NCPC File No. Z.C. 11-03

FIRST STAGE PLANNED UNIT DEVELOPMENT AND RELATED MAP AMENDMENT AT SQUARES 390, 391, 471W, 472, 472W, and 503 (HOFFMAN-STRUEVER WATERFRONT, LLC) SOUTHWEST WATERFRONT

FIRST STAGE PLANNED UNIT DEVELOPMENT AND RELATED MAP AMENDMENT AT SQUARES 390, 391, 471W, 472, 472W, AND 503 (HOFFMAN-STRUEVER WATERFRONT, LLC) SOUTHWEST WATERFRONT

September 29, 2011

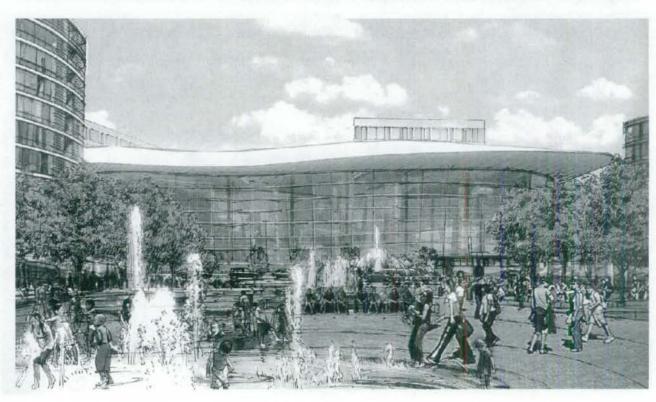
The Maine Avenue Fish Market, which is west of this proposed PUD but not included in it, is connected to the development via Market Square. Through staff consultation, the developer has eliminated a marquee sign on the roof of the Fish Market building that would have negatively impeded views to a future museum or memorial at the Banneker Park/ Overlook site.

Plan detail of the PUD design in November 2010 (left) and the current plan (right) with the buildings reoriented

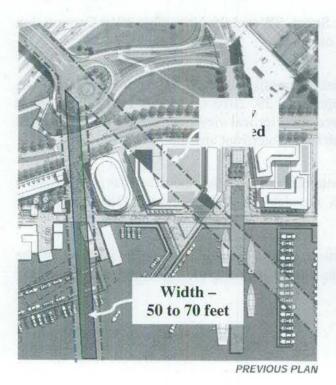
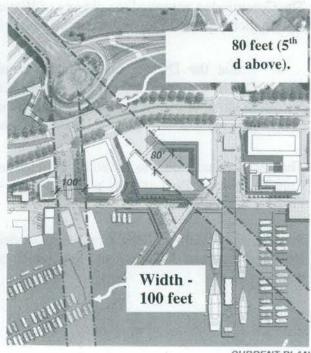
Since the November 2010 Commission meeting, staff has worked cooperatively with the Hoffman-Madison development team which has agreed to make the following changes to the design:

- Increasing the Market Square area from 50 feet to 100 feet which opens up long views from the Banneker Overlook.
- Reorienting buildings along the 10th Street, SW axis to provide a possible 80-foot wide view corridor for a future museum;

Concept stair design connecting Banneker Overlook to Market Square

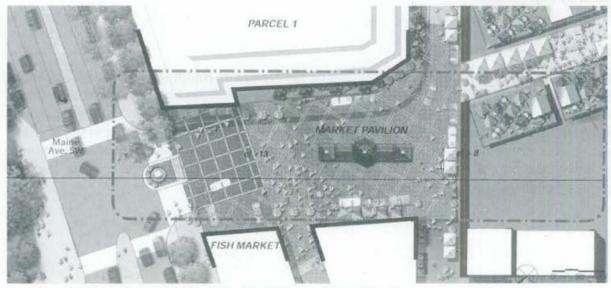
Shown below is a plan for a temporary connection between Banneker Overlook and the Market Square in the short term. The Land Development Agreement between the City and the developer requires the developer to work with the National Park Service to design and construct a permanent pedestrian connection to Banneker Overlook. To help facilitate compliance with this requirement and implement short term recommendation of the Southwest Ecodistrict Task Force, NCPC, NPS and the developer are partnering to develop a concept design for this important connection. This work will commence in the first quarter of 2012.
